**Tack Site, Sandyford SHD**

**Stage 1 Storm Water Audit**

**221140-PUNCH-XX-XX-RP-C-0001**

**March 2022**

LEGEND

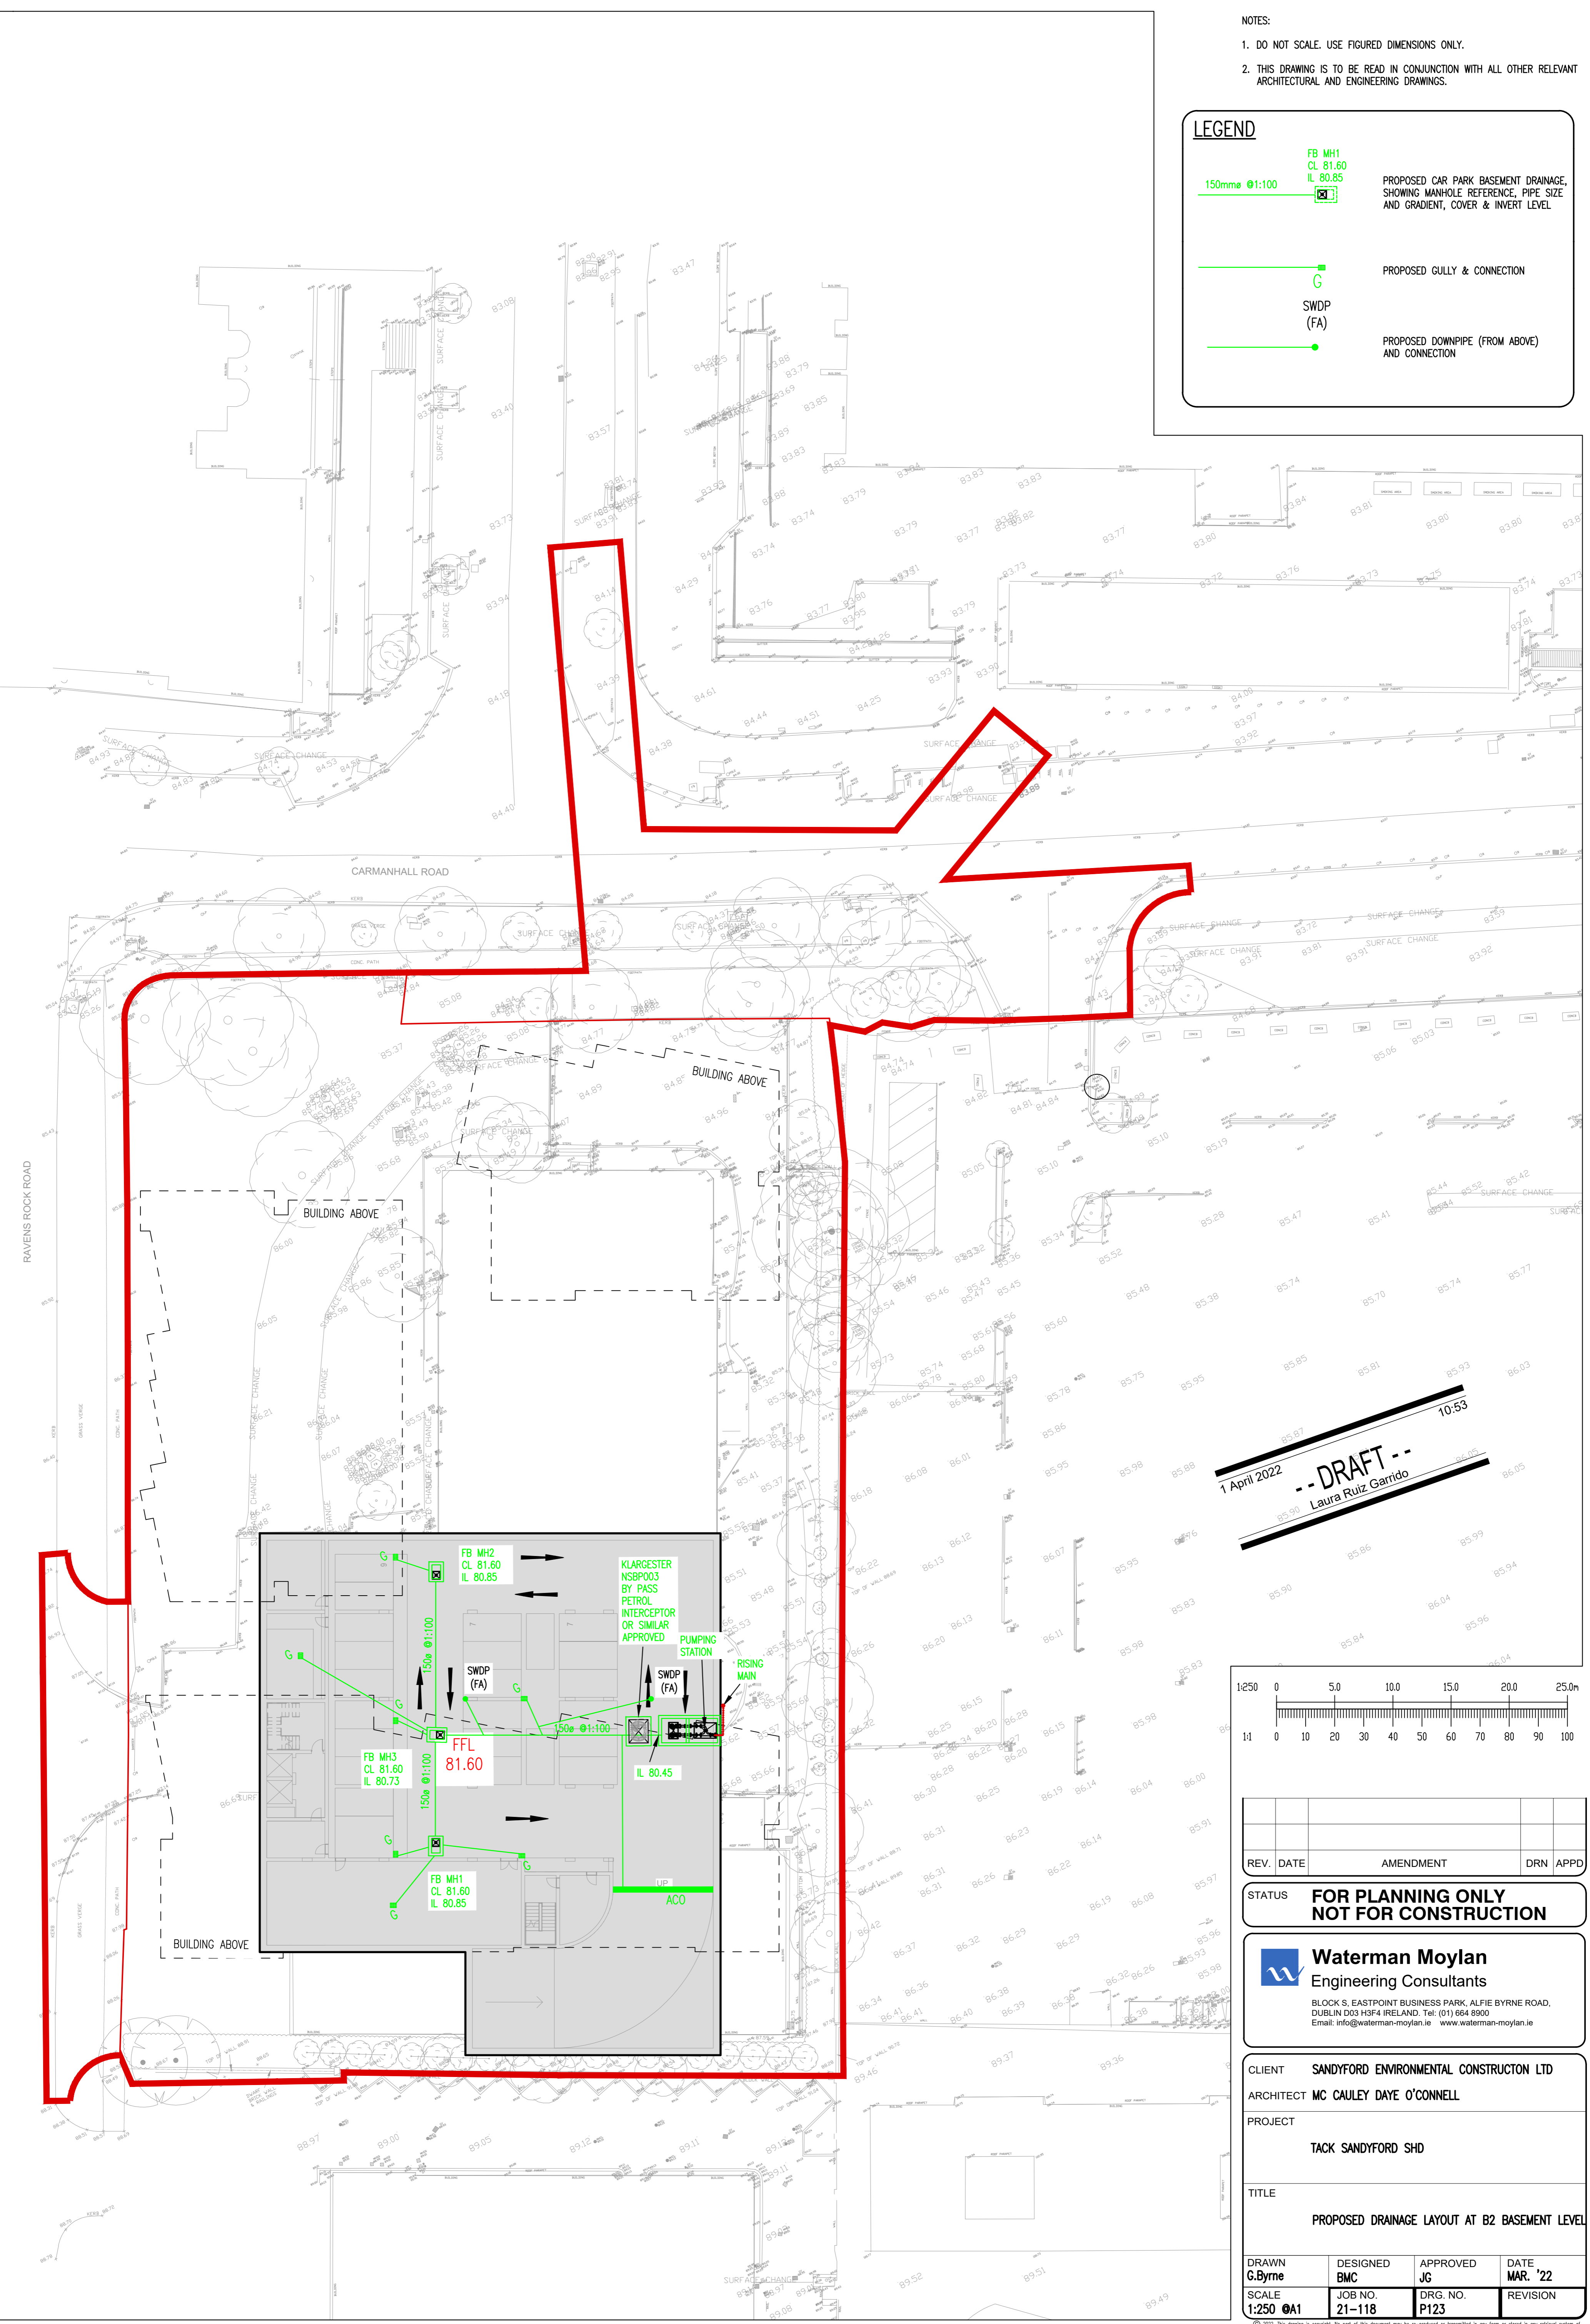
**Problem:** No proposals for the collection of surface water runoff from the under croft car park area have been shown (drawing P120).

**Recommendation:** Show proposals for collecting any runoff from the carpark including gullies etc. This should outfall via a petrol interceptor and then outfall to the foul network as per the Greater Dublin Regional Code of Practice.

2.1.1	Yes	Yes	Please refer to drawings P190 which shows an indicative layout with FFL for each of the levels to provide clarity.	
2.1.2	Yes	Yes	Refer to drawings P120, P121,P122, P123 and P124 showing the proposed car parking drainage at B1 lower ground level (undercroft car parking) and B2 Basement level.

PLAN VIEW – PROPOSED SUDS MEASURES AT PODIUM LEVEL

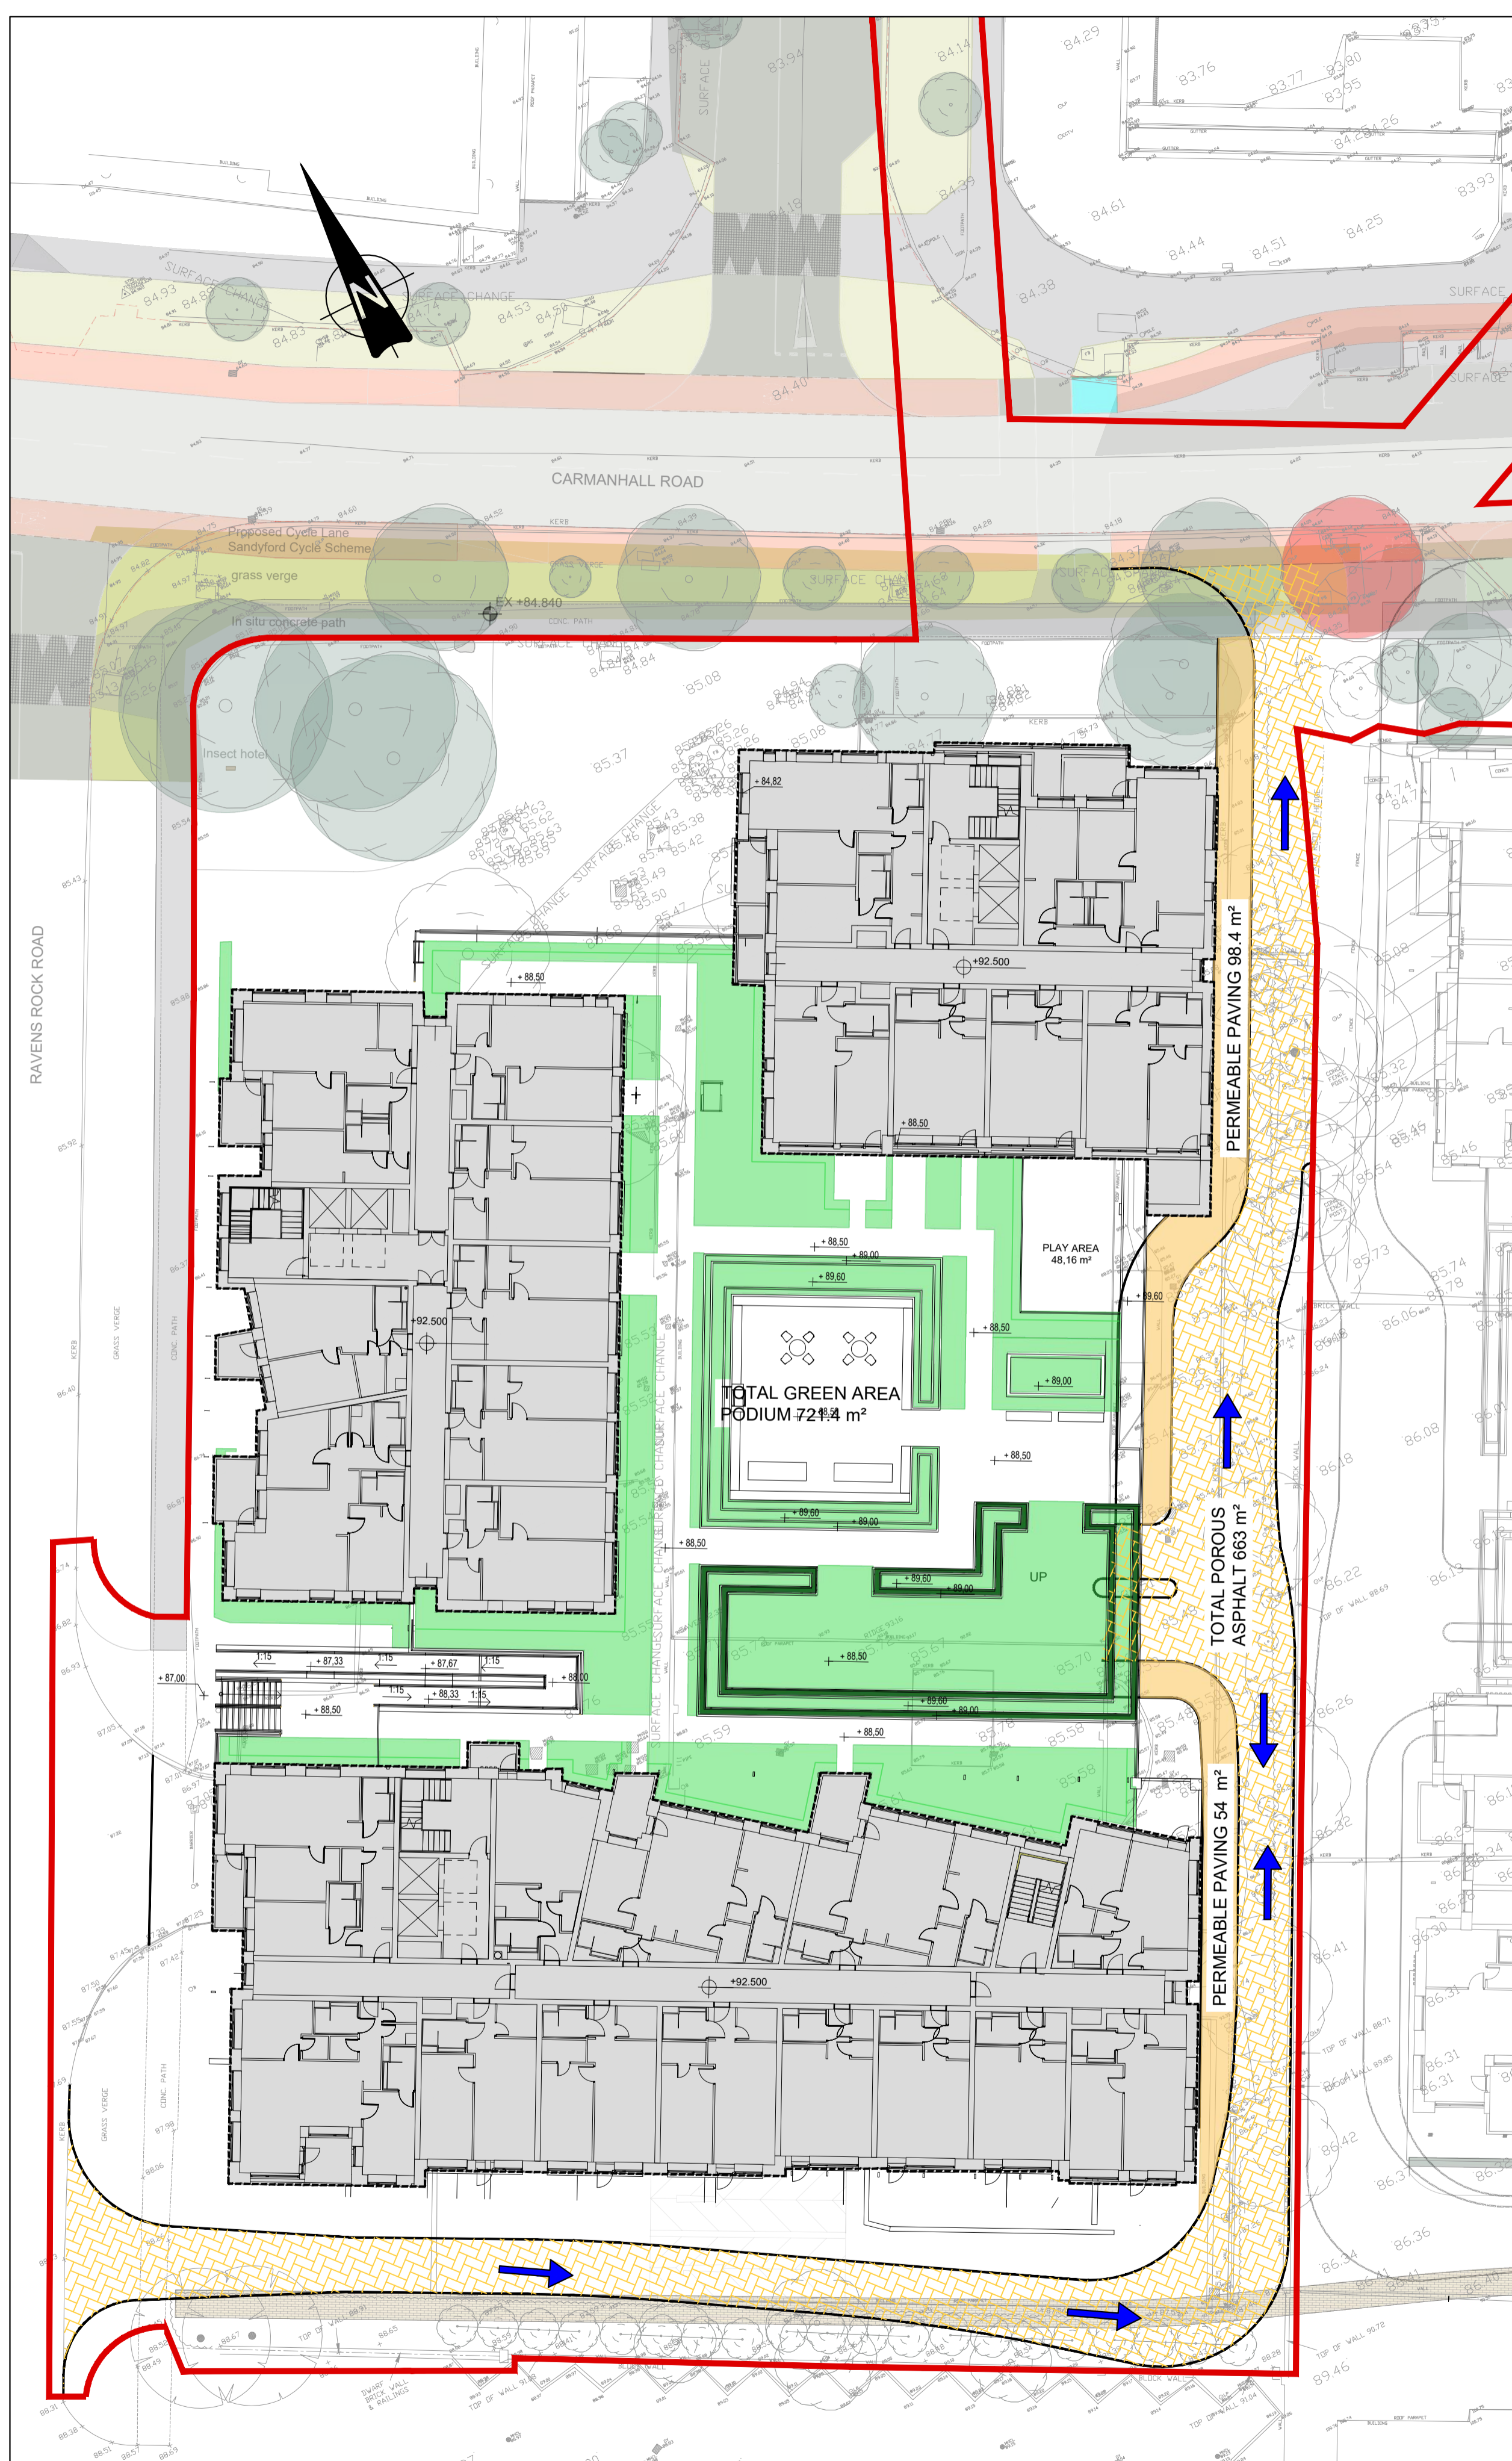
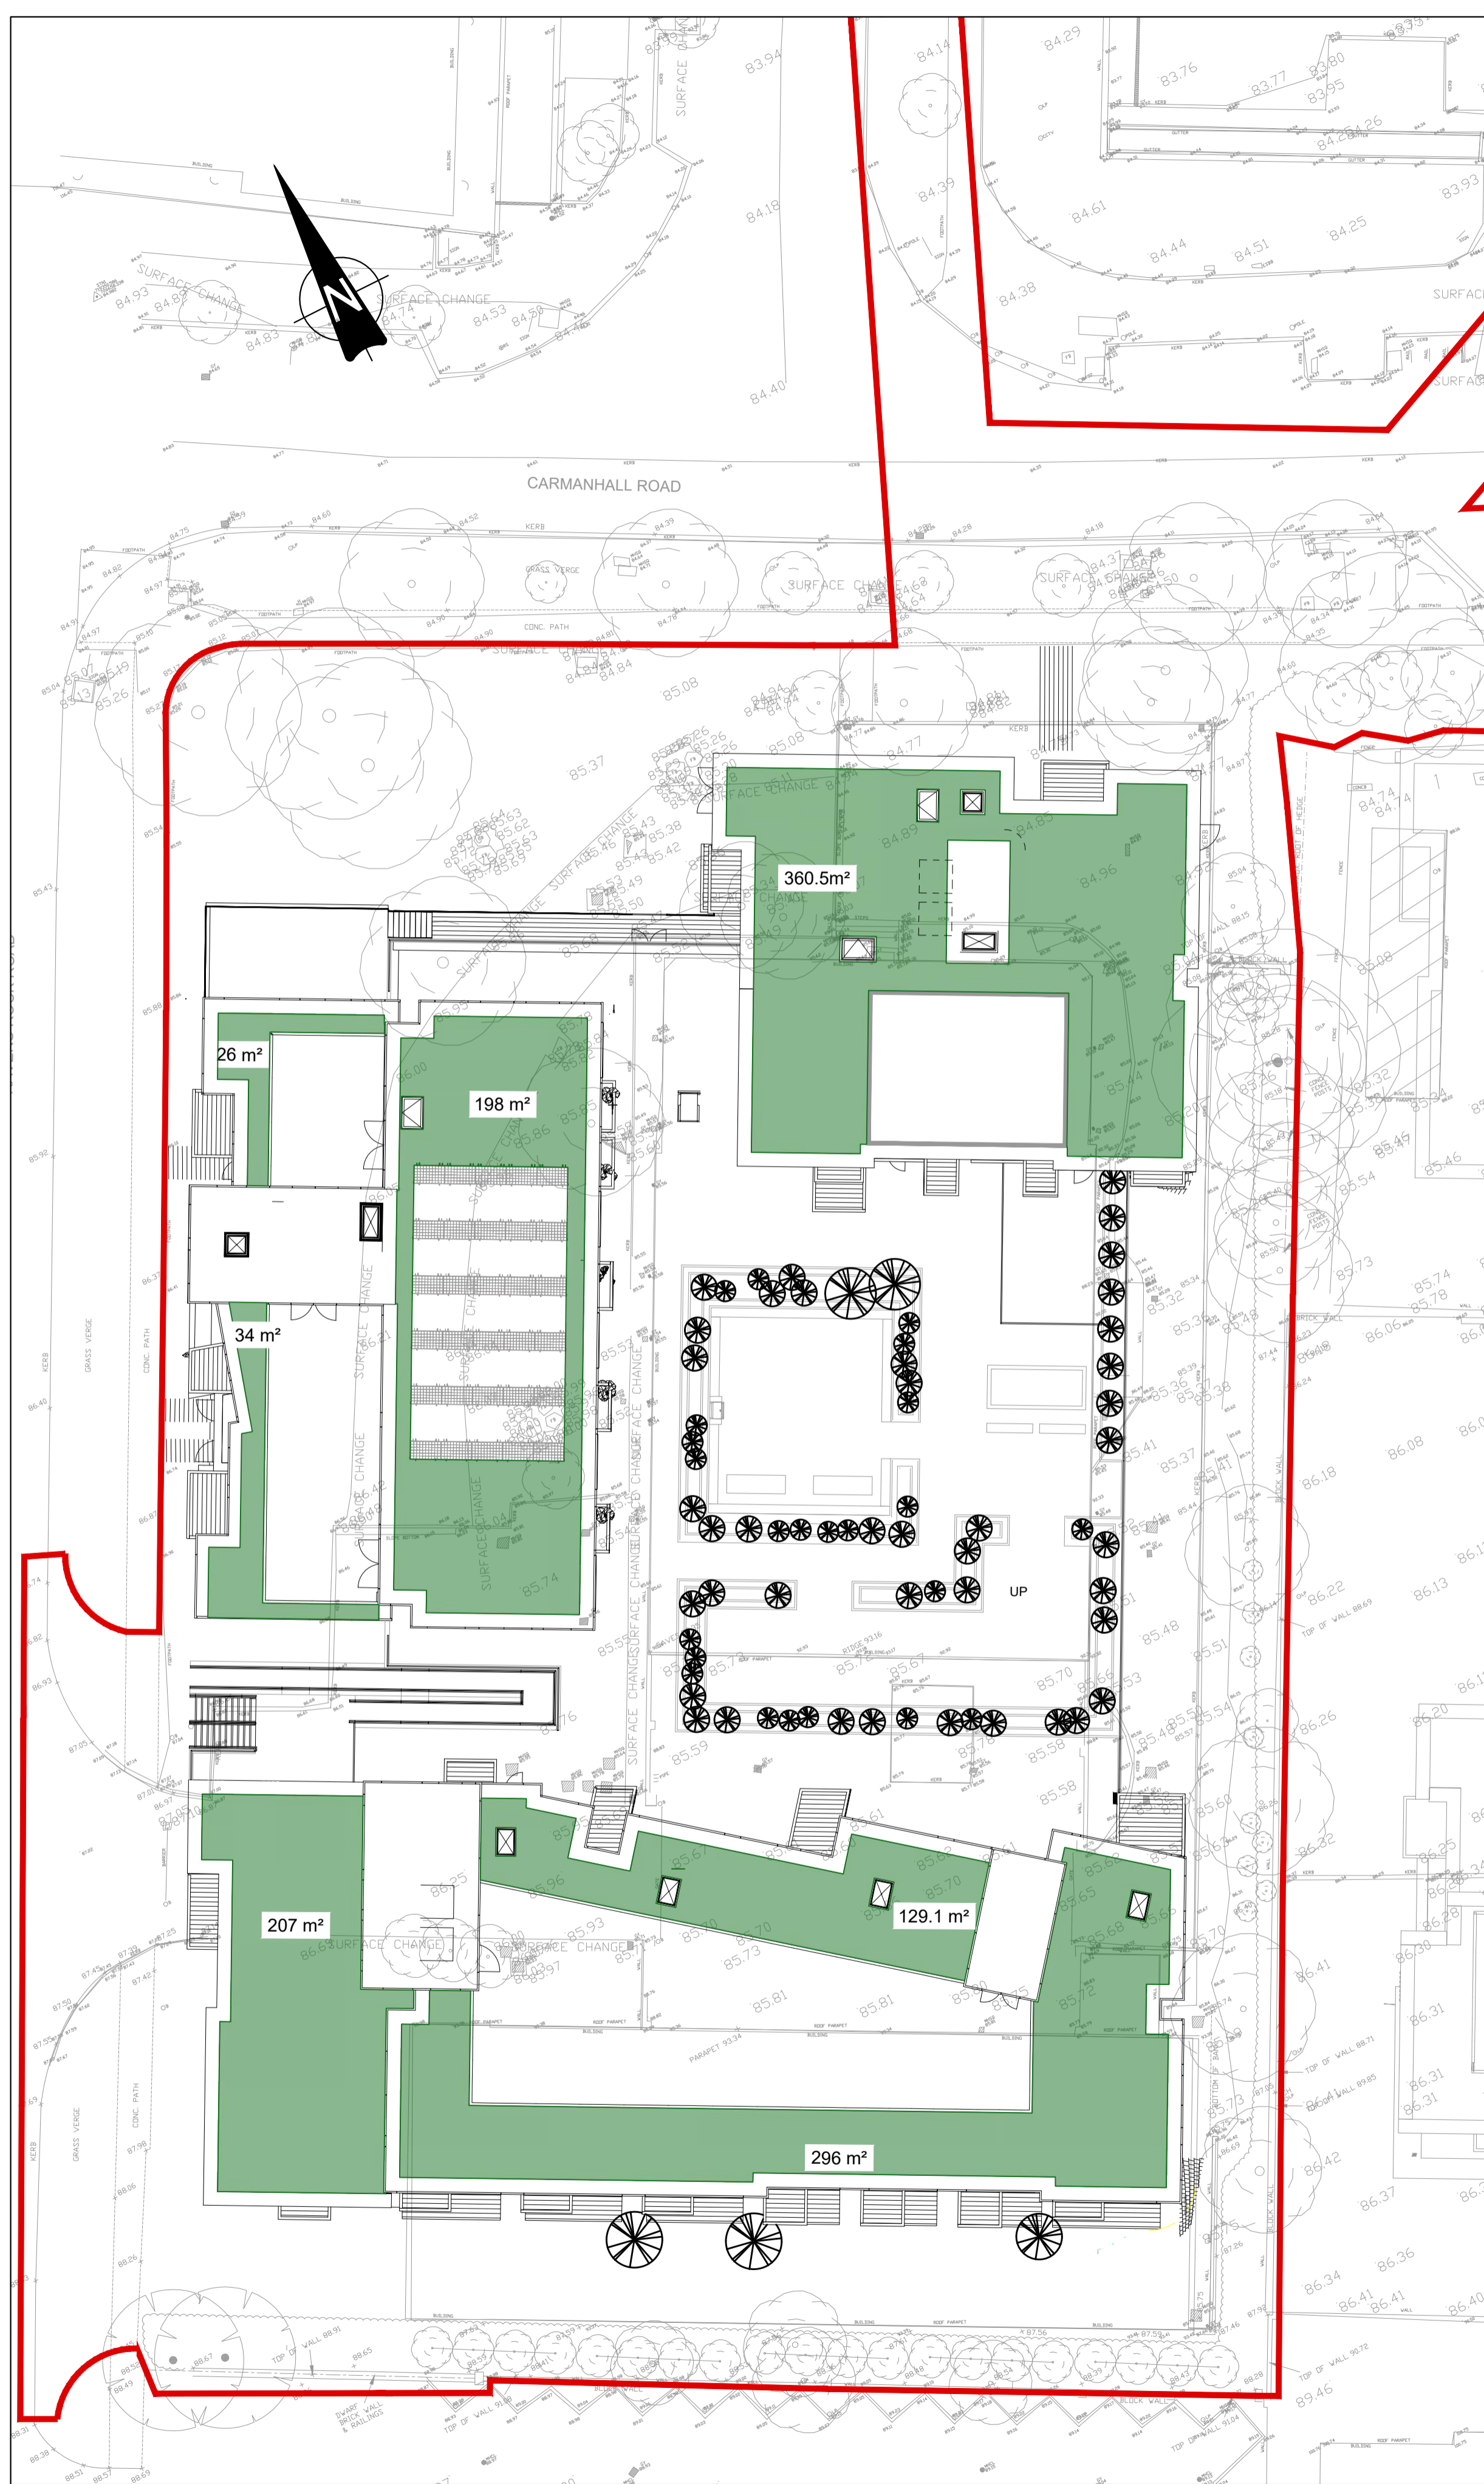
**Problem:** The provided SuDS layouts does not clearly show the surface finishes for all areas within the site boundary.

**Recommendation:** A single drawing should be prepared that shows the surface finishes for all areas within the site including hard/soft landscaping. It should be clear at what level the surfaces are i.e., Ground, podium & roof level. SuDS to be considered which include filter drains, swales, bio-retention systems, tree pit systems, pervious pavements, etc. Details of the SuDS measures to also be provided.

2.1.3	Yes	Yes	Suds finishes are indicated in updated drawing P125. In addition, please find attached with this response landscape drawing T-L1-500 showing final surfaces for the overall development.
